Catalog: 2000 Soft Parts Catalog, page 46

Subject: Clarification of which solenoids to use for General Motors 4L60E transmissions.

Catalog Update

4L60-E

31344	37347A	18350	37346	37346	37344UA
PWM (95-up) 3-2 Control (93-95)	3-2 On/ Off (96-up)	EPC (Variable Force Motor)	Shift "A"	Shift "B"	Lockup - w/o Harness (in Pump)

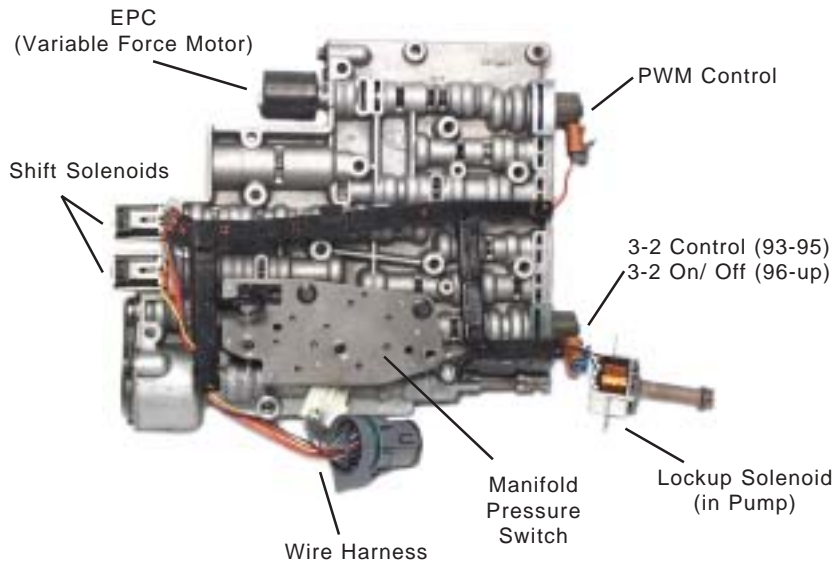
- (1) 37347A 3-2 On/ Off (the 3-2 On/ Off solenoid replaces 3-2 control from 1995)
- (1) 31344 PWM control
- (1) 37344UA_RS Lockup (w/o Harness)
- (1) 37346_OE Shift "A"
- (1) 37346_OE Shift "B"
- (1) 18350_OE EPC (Variable Force Motor)

- (1) 31344 3-2 control
- (1) 37344UA_RS Lockup (w/o Harness)
- (1) 37346_OE Shift "A"
- (1) 37346_OE Shift "B"
- (1) 18350_OE EPC (Variable Force Motor)

- (1) 31344 3-2 control
- (1) 31344 PWM control
- (1) 37344UA_RS Lockup (w/o Harness)
- (1) 37346_OE Shift "A"
- (1) 37346_OE Shift "B"
- (1) 18350_OE EPC (Variable Force Motor)
